**5.0 Design Development**

### 5.1 - Discussion with Camden Council Design Officer 22.09 2010

Fig - 5.2.4 - Elevation Study Showing the Shifting Tessellated Pattern

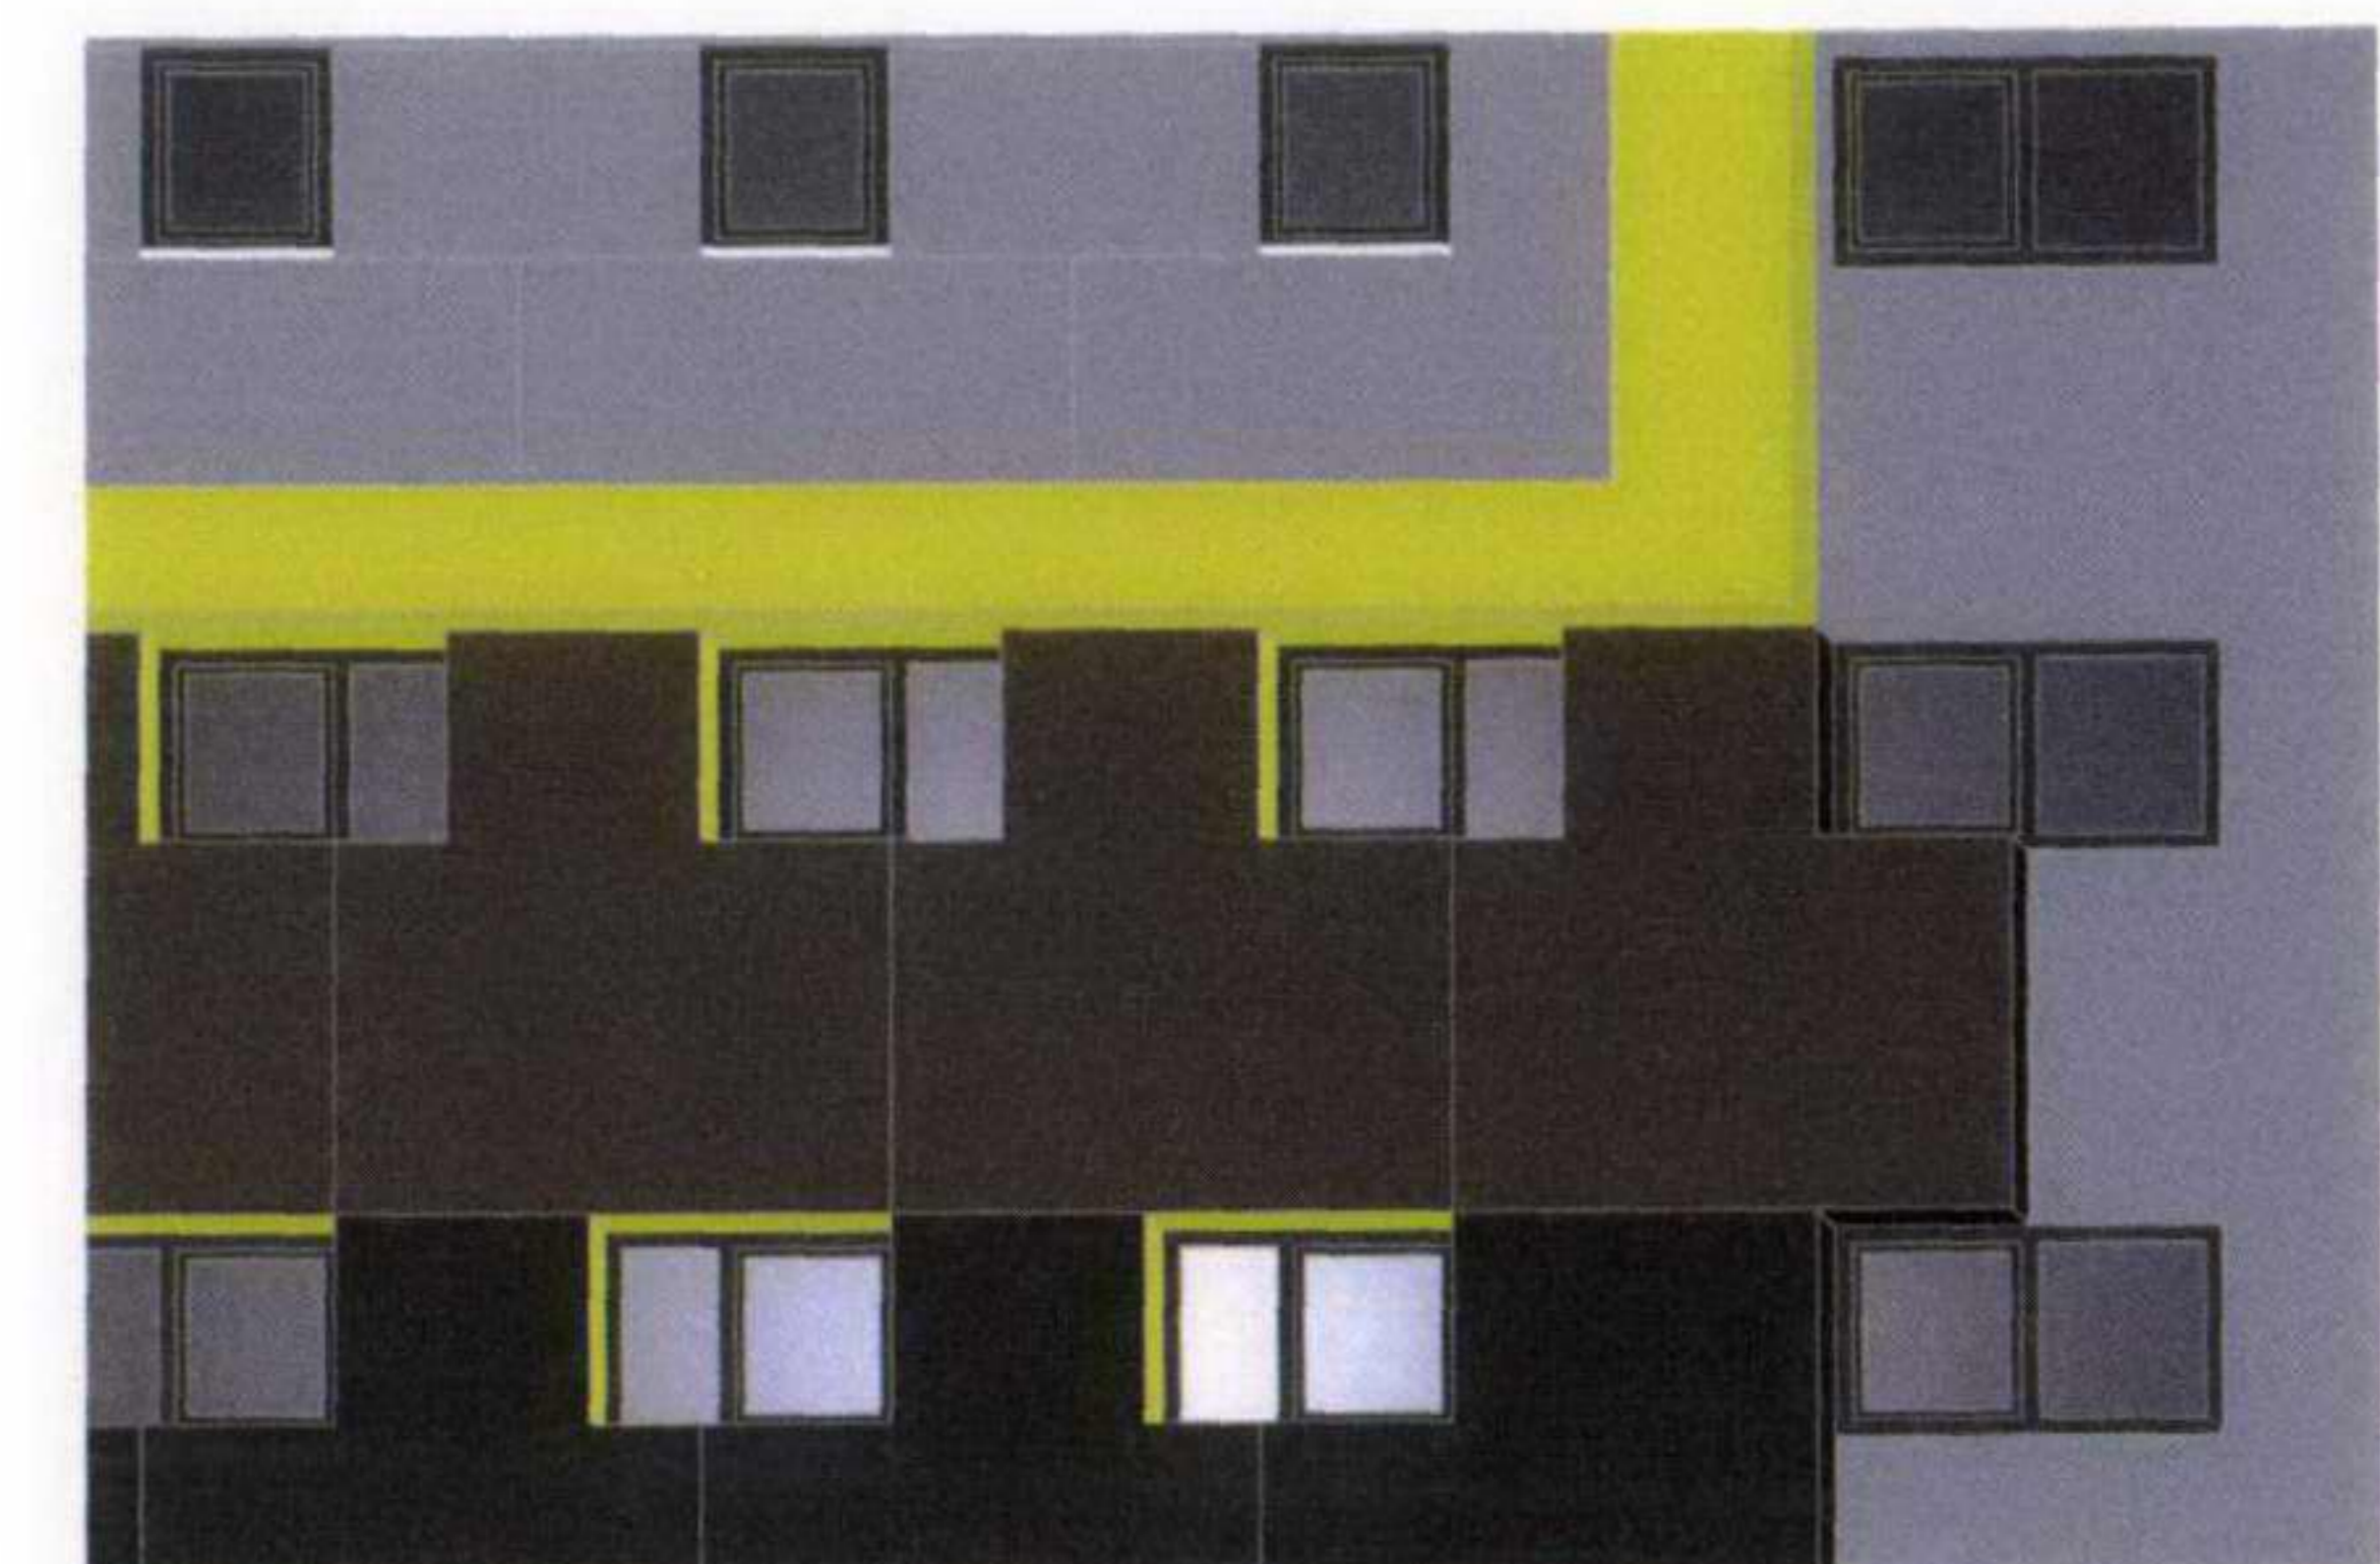
- The overall mass and concept of the design was acceptable.
- The principle of the wall to Travis Perkins and the entrances was acceptable but requires more detailed design before the final planning application. More openness to the operations behind was preferred.
- The stepped design of the podium deck was agreed.
- The new location of the main entrance was discussed and agreed as positive.
- The elevations were discussed and it was agreed that more work would be put into their design. Positive elements were the attempt to break up the mass with the box like structures. The shifting tessellated façade was less welcome, but the principle of how we were trying to express the concept was encouraged.
- More investigation into materials is required with a suggestion to investigate more traditional materials such as brick cladding, to be more contextual and solid.

Fig - 5.3.1 - Elevation to St Pancras Way

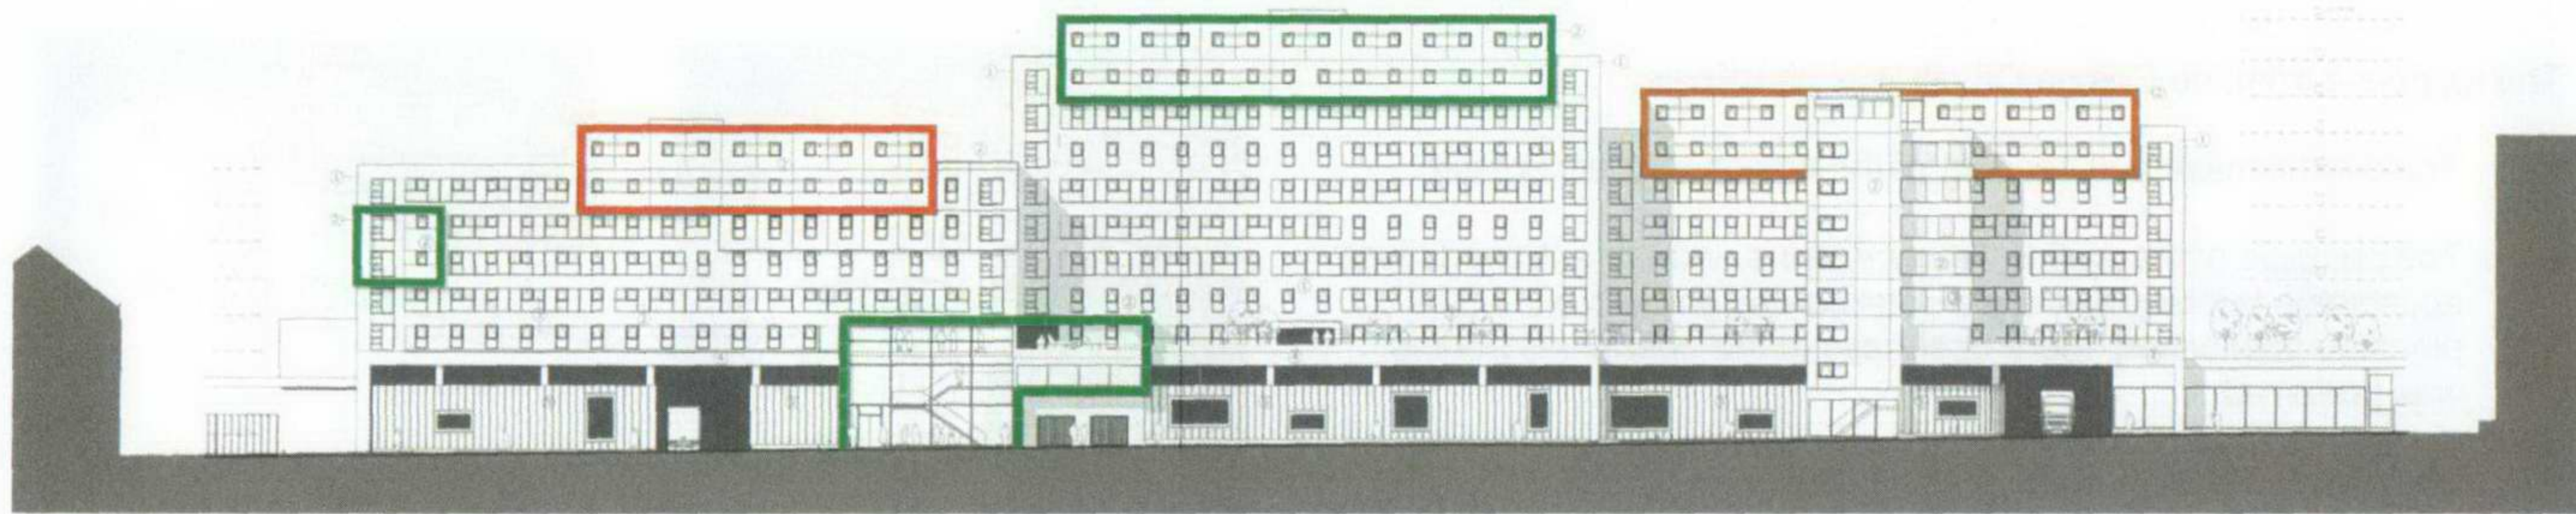
- The overall design should not get so busy that the concept is lost. 3d views will allow this to be tested.
- The material palette should be limited to aid in the clarification of the concept.

- The large high level boxes are overly dominant in the design and should be fragmented.
- The interlocking box detail is strong and could be developed further in other parts of the scheme.

- The plant room area to the south of the site needs some further development, and should be integrated into the building fabric, rather than appear as a bolt on.

- The concept and design of the Travis Perkins wall is generally good but may need some minor design development.
- The depth of the façade is limited by the modular construction, to a 400mm step out from the modules. It's important to look at how this could be best maximised to prevent the façade becoming too flat. The macro and intermediate scale of the development is working well, but more needs to be done on the micro scale.

Fig - 5.4.2 - Elevation to St Pancras Way

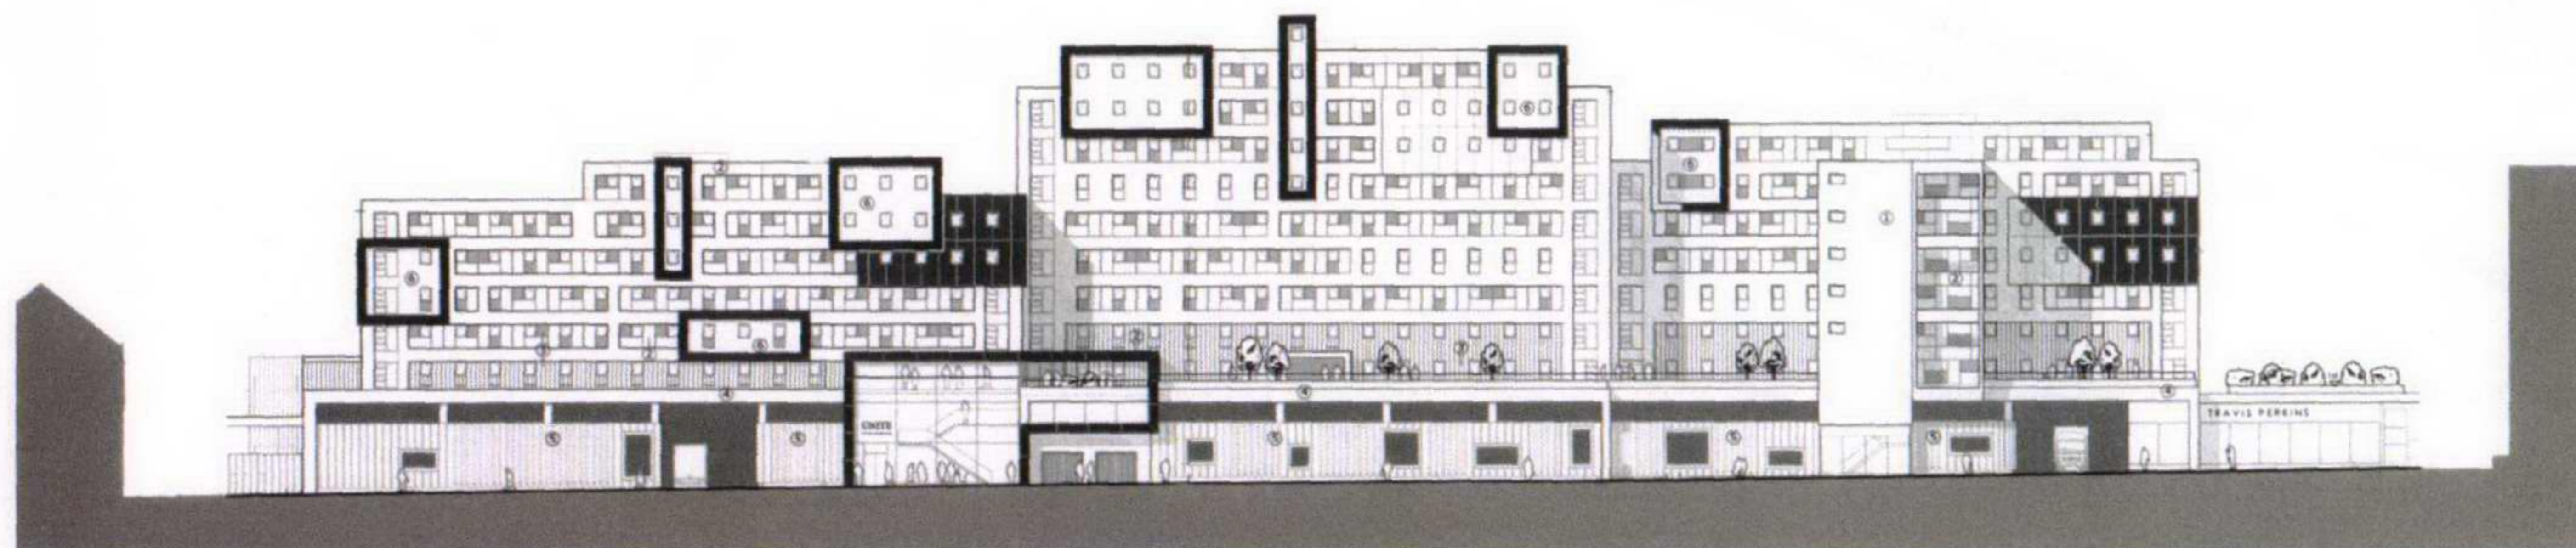
- The façade design direction is generally successful.
- The fragmenting of the large boxes is successful but perhaps requires a little more work to ensure the composition is strong.

- The façade is still rather flat, given that some elements of the scheme are very expressive. It was agreed that the feasibility of expressing a few of the boxes by leaning them out of the façade much more, would be investigated.

- The materials were discussed. Options could be investigated to further reduce the palette, for example making the boxes the same red as the podium level metal treatment.

- The basic treatment of the plant room area to the South of the site is generally good, although some attention to materials and the relationship to St Mungos next door could be looked at further.

Fig - 5.4.4 - Landscape Design Sketches

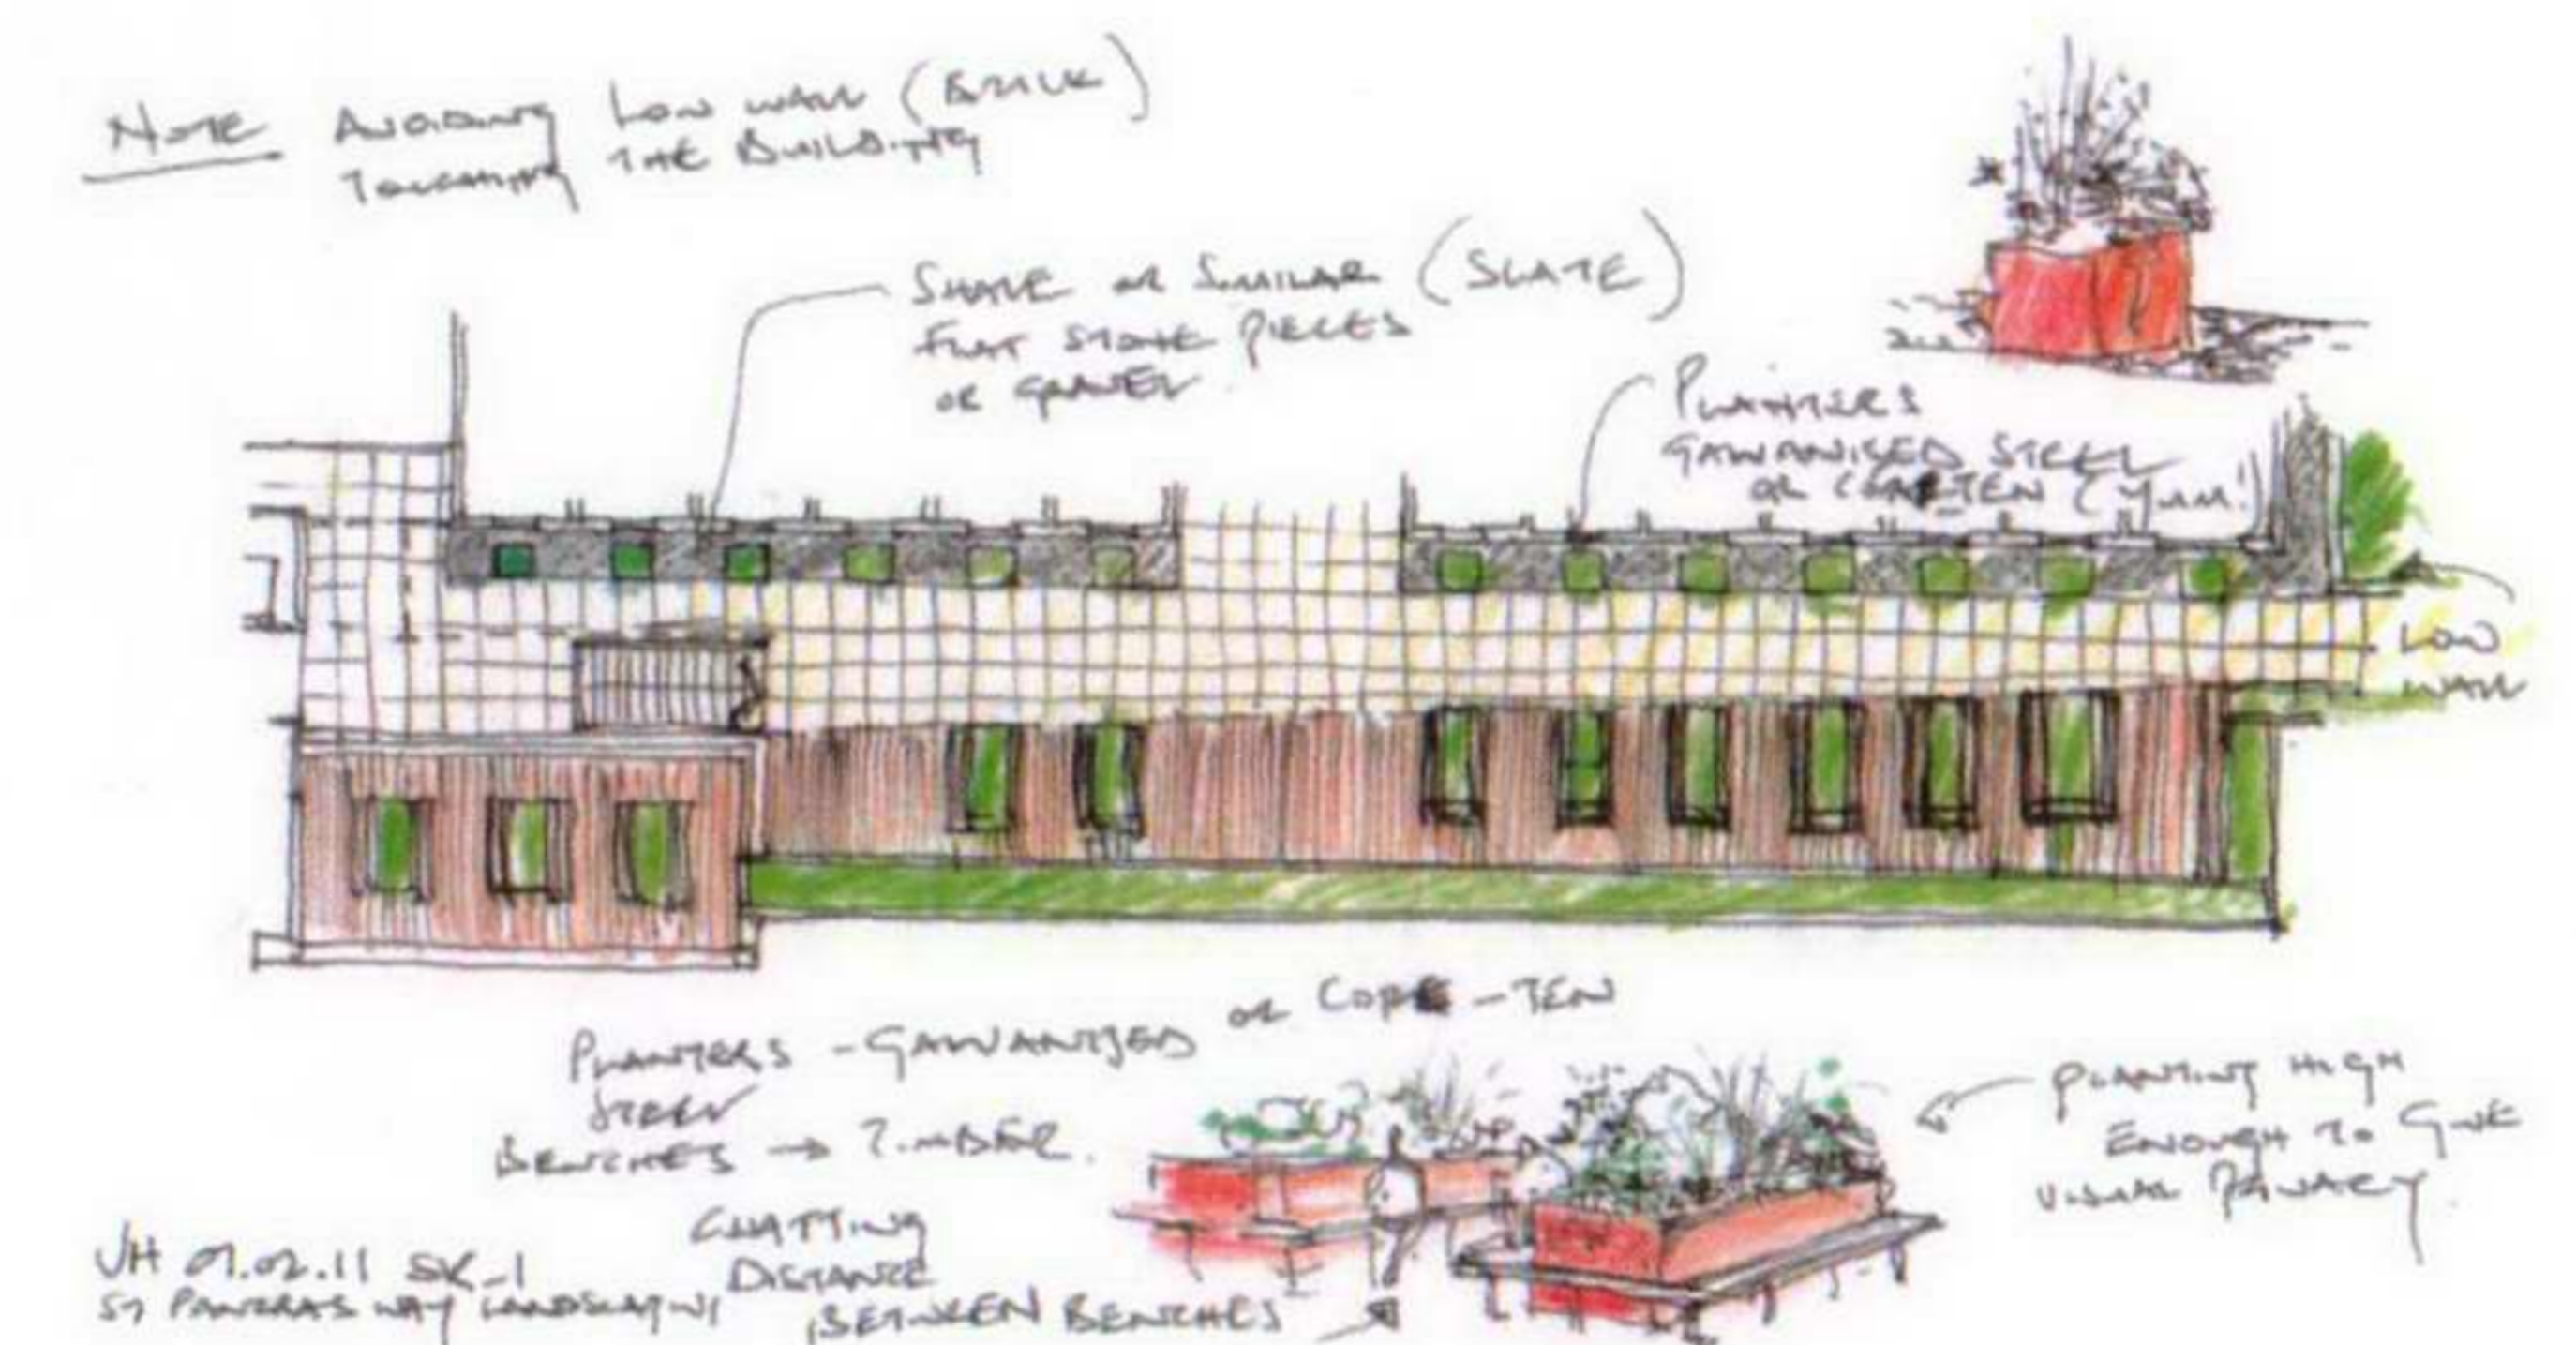
- A landscaping sketch and canopy sketch were tabled and generally considered to be acceptable and should be incorporated into the final design.
